Conceptual Review Agenda

Monday, December 15, 2014

Re: 7325 S Shields - 10 Lot Subdivision

Comment Summary:

CONCEPTUAL SITE PLAN

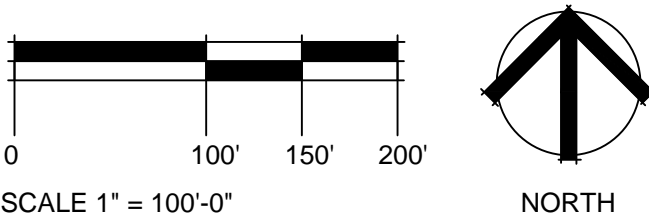
1. LUC 4.2 Urban Estate zoning requires a 30 foot front, 25 foot rear, and 20 foot side setbacks.
If you are proposing a cluster development please see LUC section 4.2(E)(2)
2. LUC 3.5.2(F) The garage door standards do apply.
3. LUC 3.2.1 A landscape plan is required.
4. UE allows for single-family and two-family dwellings.
- 4.

2. However, Shields Street in this area a major, high speed, two lane arterial, and based on section 8.2.5 of LCUASS, a northbound left turn lane will be required into the access.
3. Work with the engineering department on any adjacent street improvements (i.e. sidewalks) that will be required.

2. Onsite detention is required for the runoff volume difference between the 100 year developed inflow rate and the 2 year historic release rate. The outfall for this site is Lang Gulch. The developer will need to provide adequate conveyance of the developed runoff into Lang Gulch, which may require the acquisition of offsite drainage easements.

Private roads shall meet minimum fire lane standards. All portions of any residence shall be within 150' of the fire access road. Specifications provided below.

9. Is the access to the lots proposed to be a public street or a private drive? If it is to be a public street, right-of-way will need to be dedicated and the roadway designed and constructed to standards. Based on the lot sizes proposed here a rural residential street section can be used.

3. 100' lot width is required in the UE zone.
4. This project looks like a good candidate for a private drive access, with a design tailored to the rural city edge setting, as opposed to a public street. Staff will discuss requirements at an upcoming Transportation Coordination meeting to provide further guidance. In the meantime, applicants are encouraged to think about the desired design for this facility.

PRELIMINARY
SITE PLAN

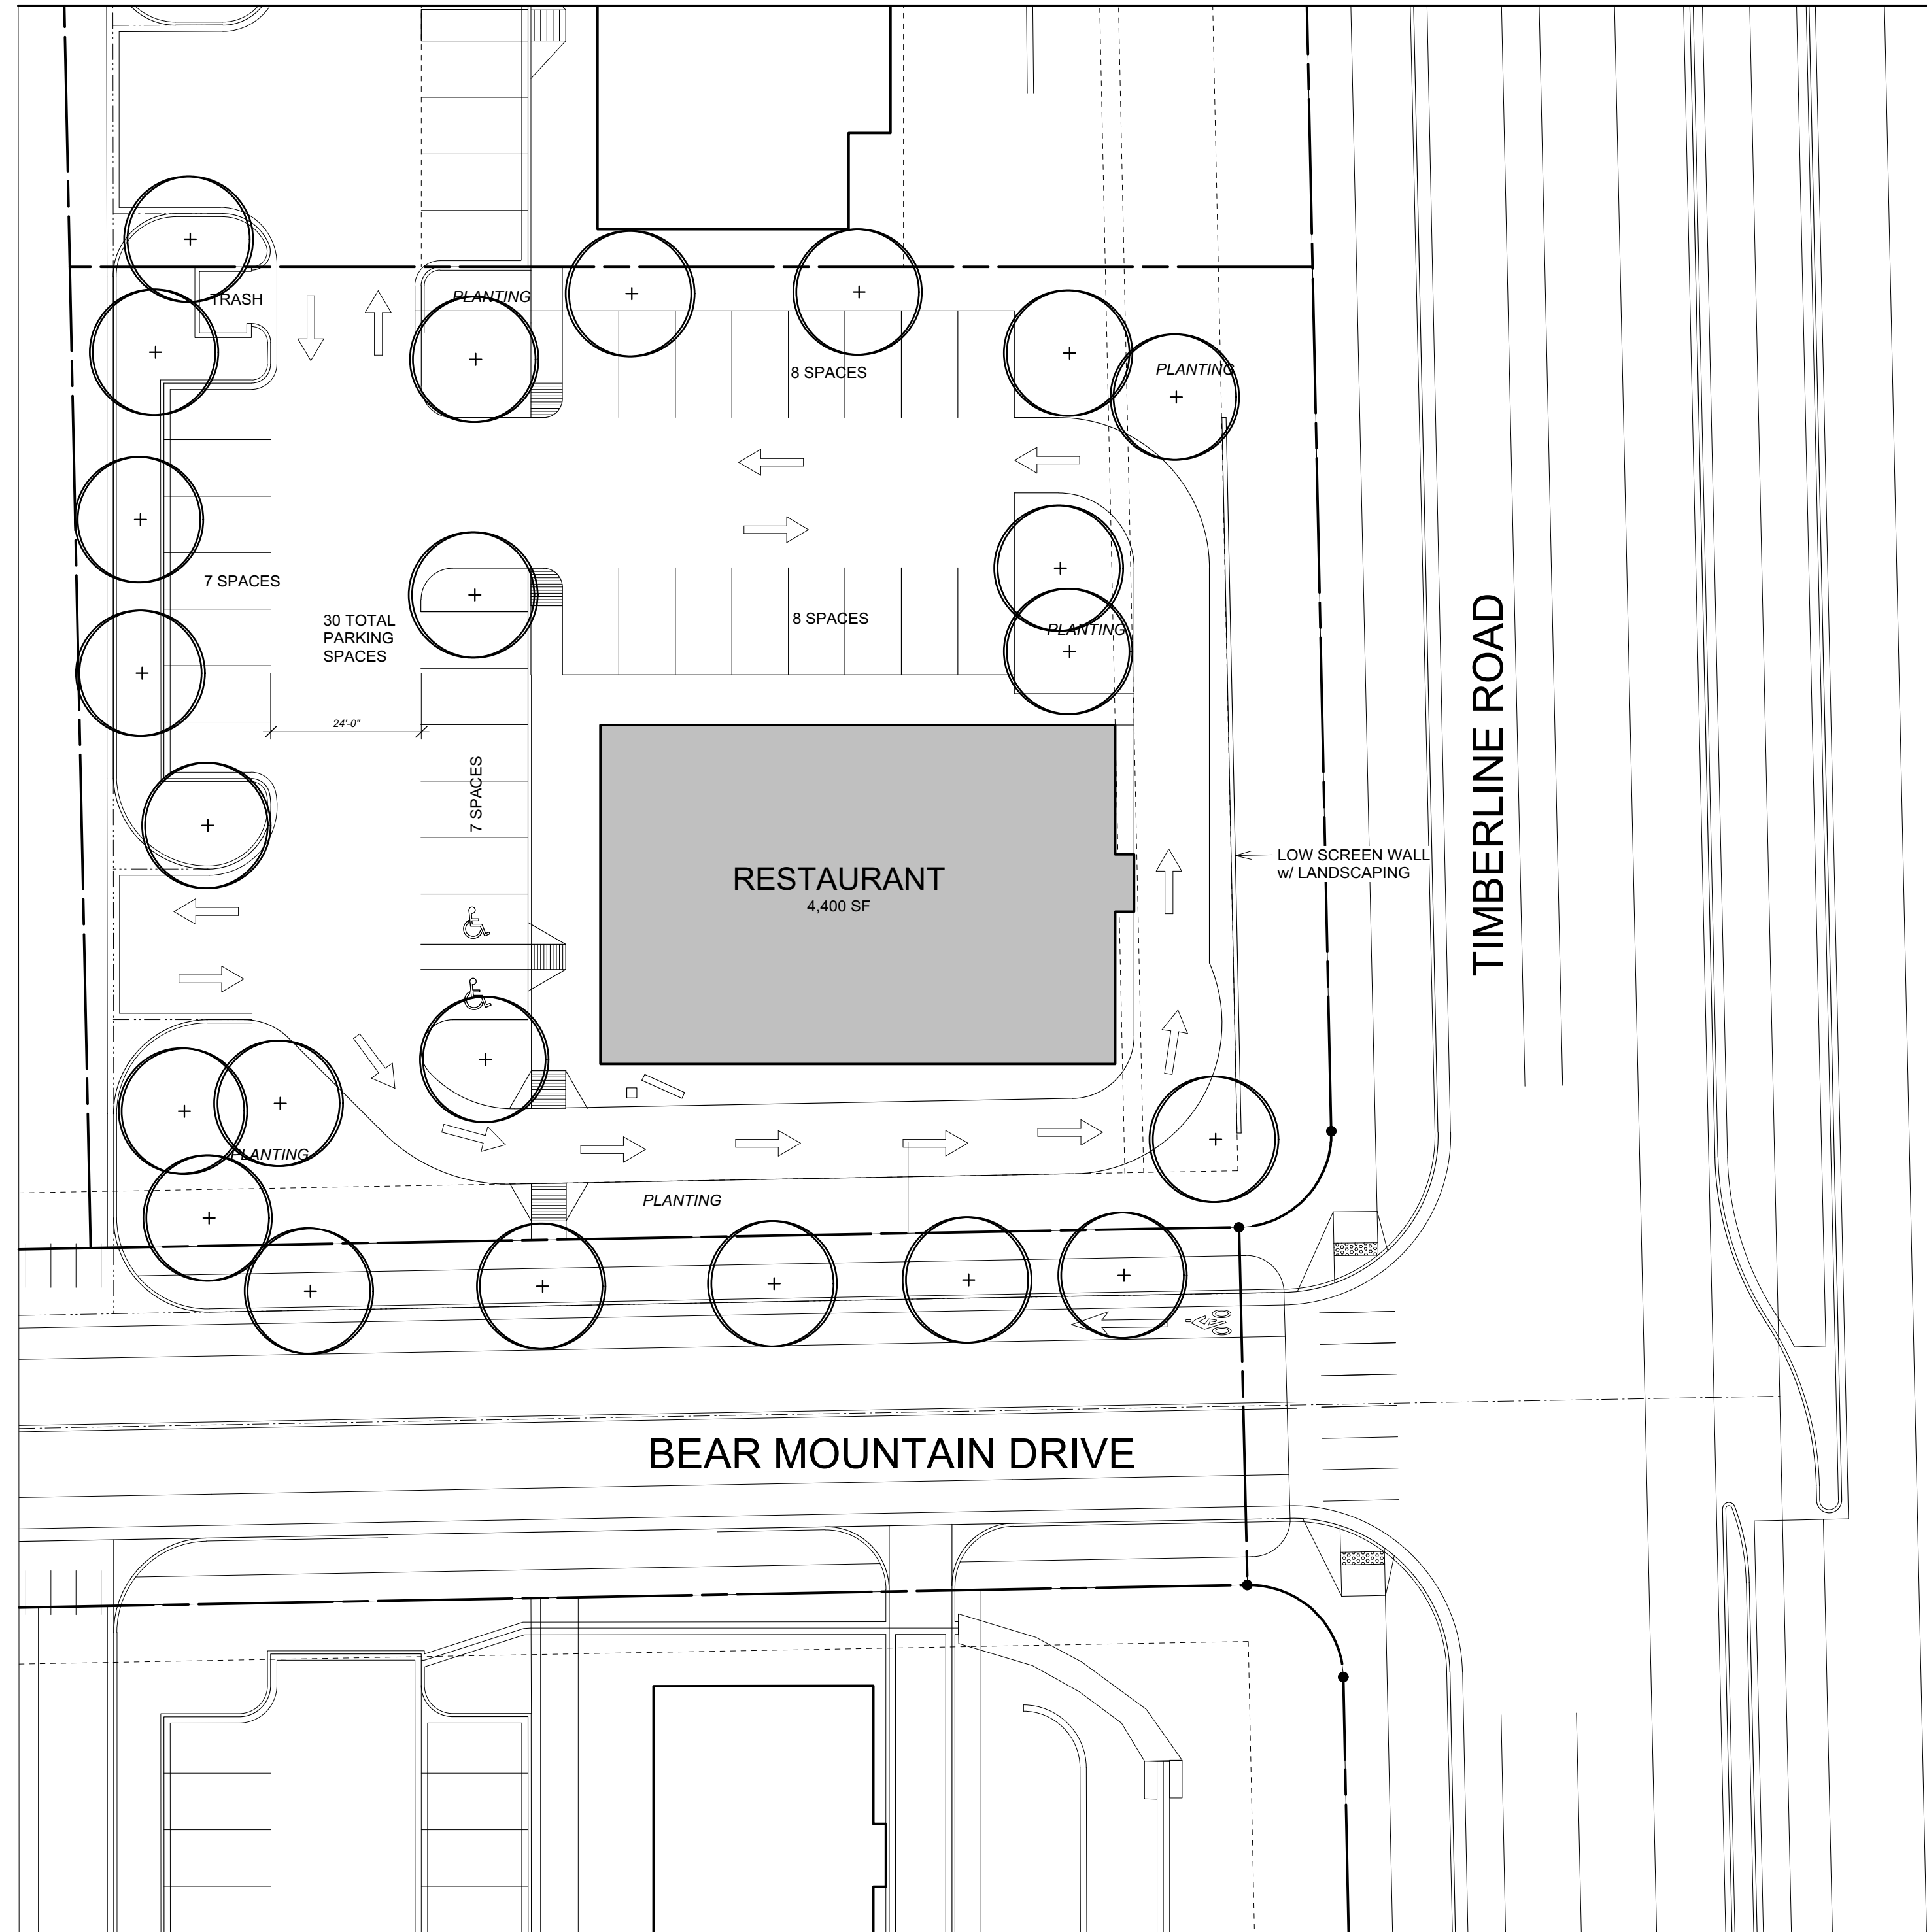
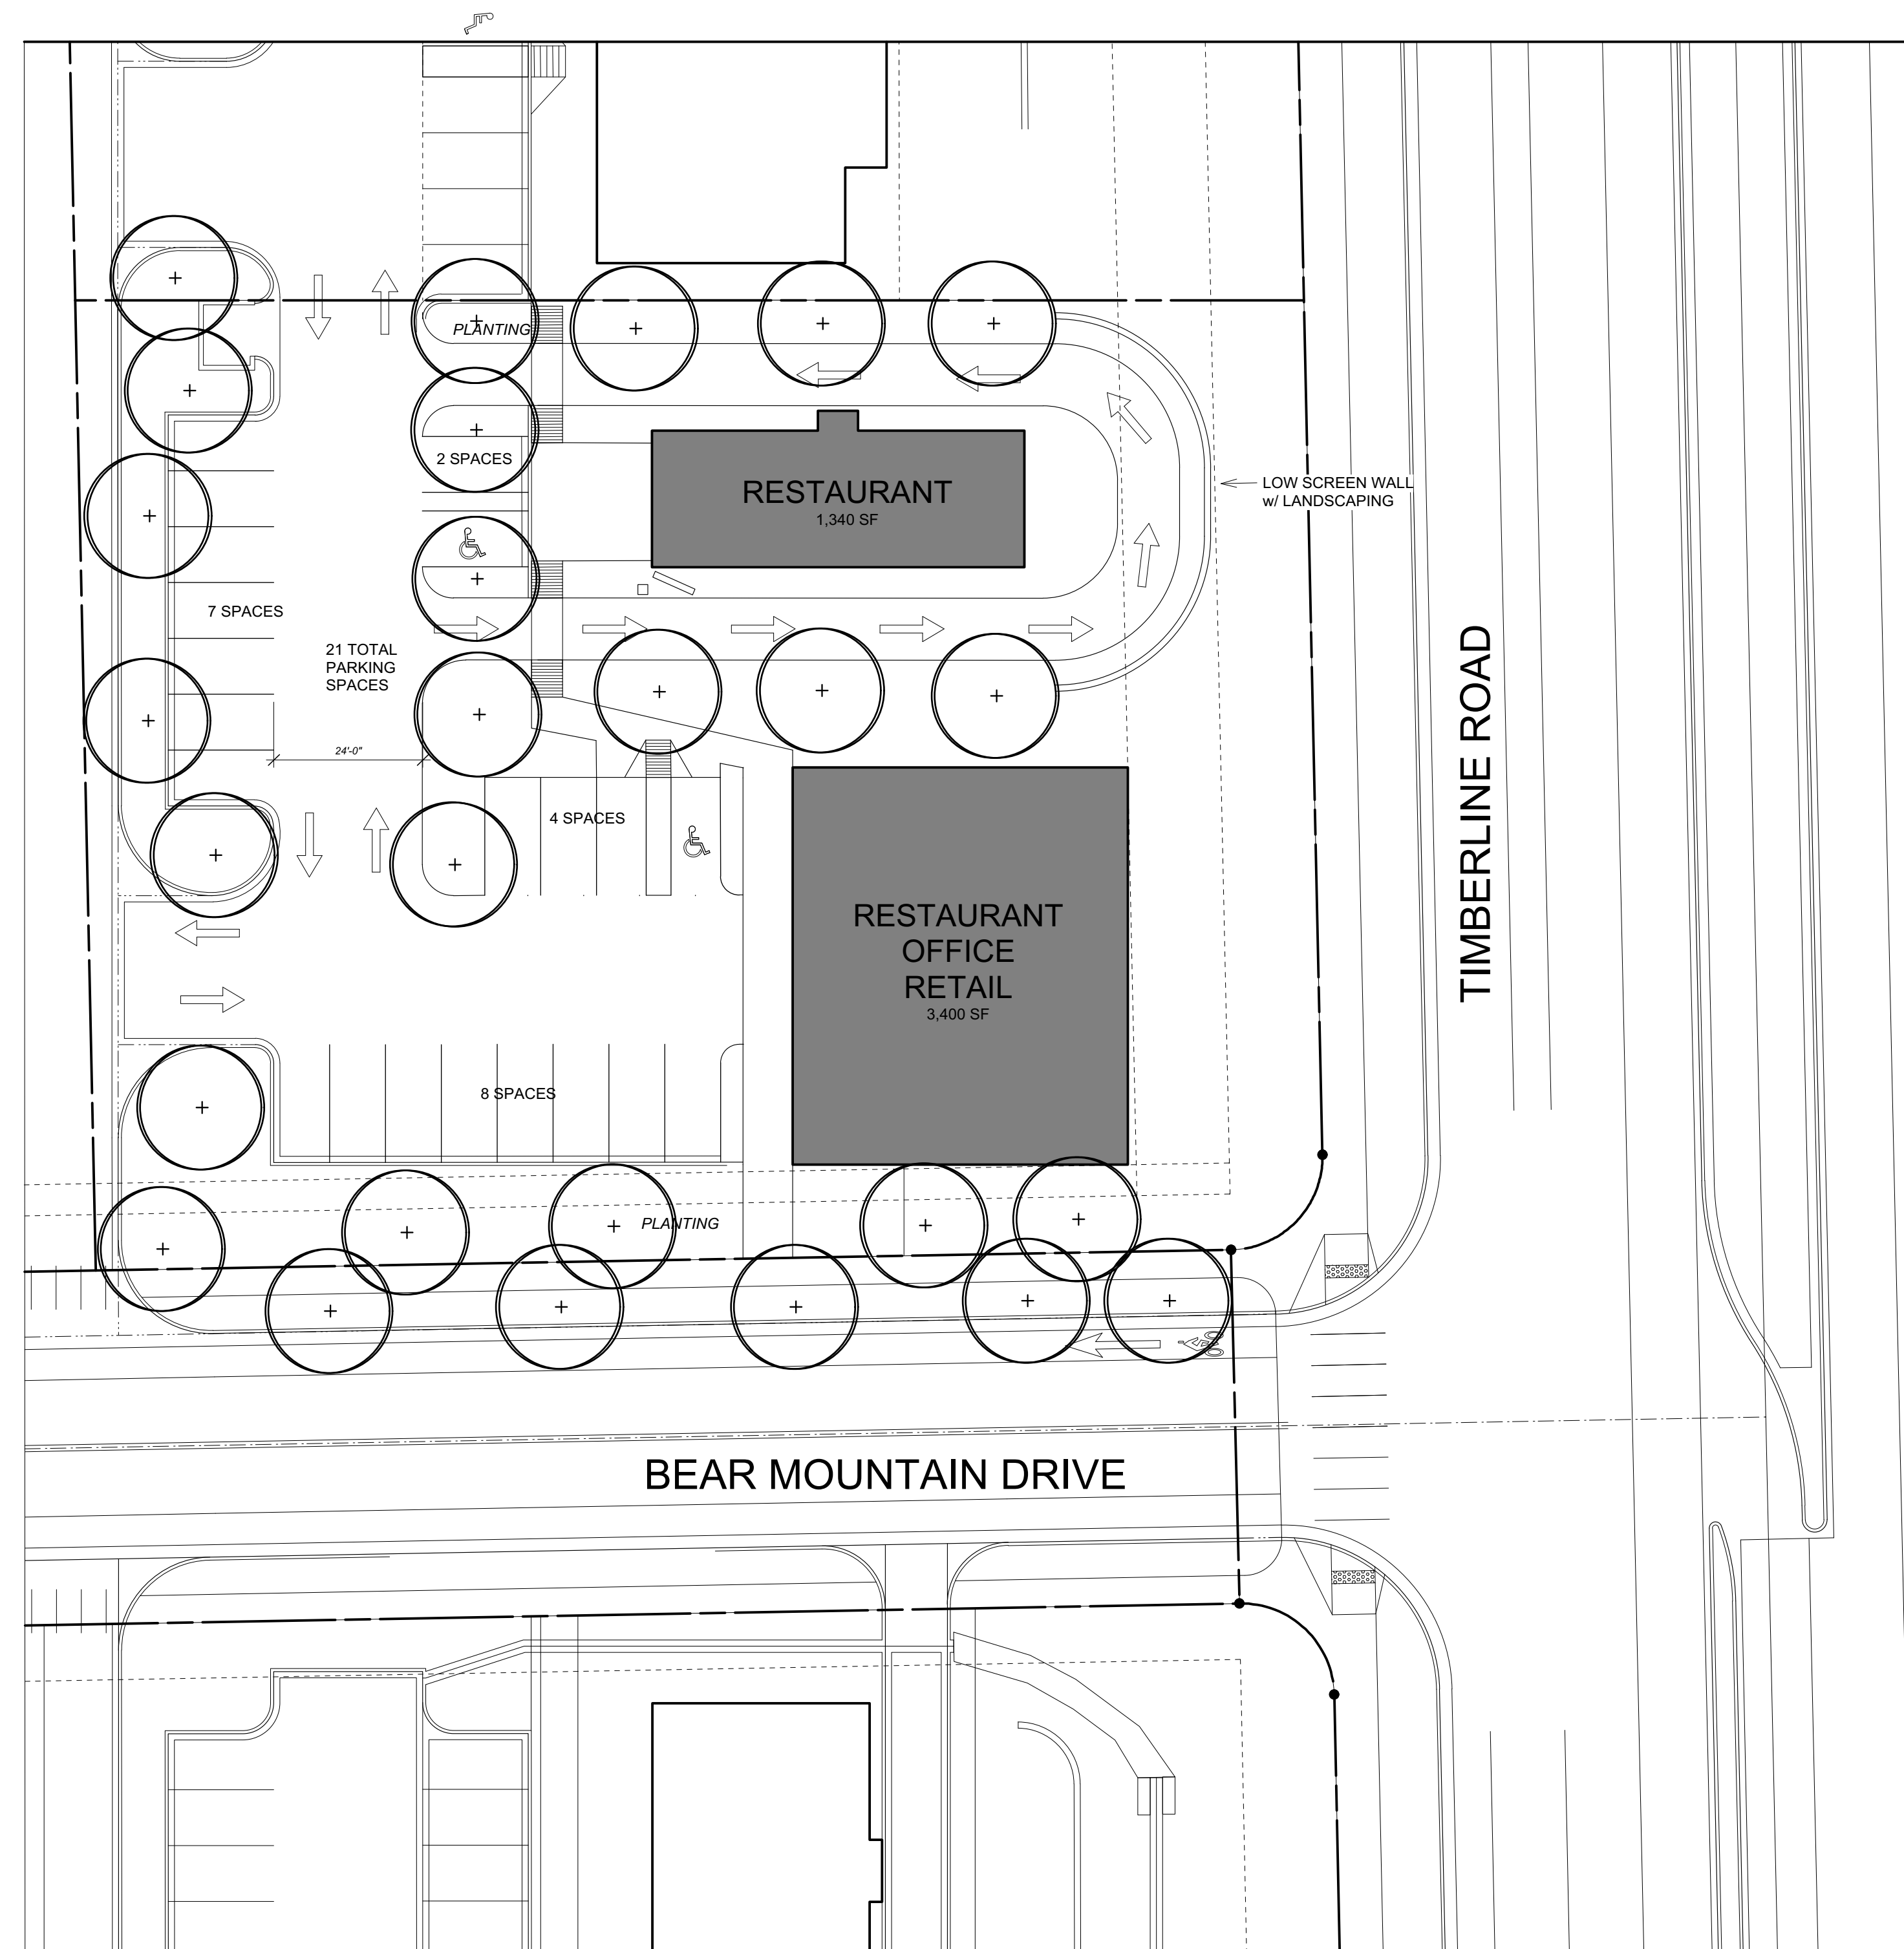
1. Sidewalk connectivity is an issue. Vehicle use areas, including parking areas and drive through lanes, are not permitted between the building and the streets, unless a connecting sidewalk can be provided with the site plan. This is outlined in land use code section 3.5.3(C). This connecting sidewalk must link the street sidewalk to the building entrance without crossing parking drives or drive-through lanes. Neither option one or two meet this standard.

2. Both proposed site plan layouts propose drive-through lanes that are considerably closer to Timberline Road than the approved plan. The drive through lanes are on top of ½ of the drainage swale shown on the current utility plans. In addition to the drainage challenges this may cause, this close proximity also makes an appropriate transition from Timberline to the drive isle much more difficult. Screen walls in this area may need to be tall and there is not sufficient landscape space provided with the concepts to avoid an abrupt transition. More landscape space is needed with terraced retaining or screen walls for a more gradual transition. The Burger King layout on the approved plans is a good example of the space needed to make an appropriate transition using walls combined with landscaping.

3. Staff recommends incorporating a pedestrian crossing from the Timberline street sidewalk to connect between lot one and two so that these lots provide a direct connection to the street as outlined in comment one.

1. Sidewalk connectivity is an issue. Vehicle use areas, including parking areas and drive through lanes, are not permitted between the building and the streets, unless a connecting sidewalk can be provided with the site plan. This is outlined in land use code section 3.5.3(C). This connecting sidewalk must link the street sidewalk to the building entrance without crossing parking drives or drive-through lanes. Neither option one or two meet this standard.

2. Both proposed site plan layouts propose drive-through lanes that are considerably closer to Timberline Road than the approved plan. The drive through lanes are on top of ½ of the drainage swale shown on the current utility plans. In addition to the drainage challenges this may cause, this close proximity also makes an appropriate transition from Timberline to the proposed plan's drive isle much more difficult. Screen walls in this area may need to be tall and there is not sufficient landscape space provided with the concepts to avoid an abrupt transition. More landscape space is needed with terraced retaining or screen walls for a more gradual transition. The Burger King layout on the approved plans is a good example of the space needed to make an appropriate transition using walls combined with landscaping.
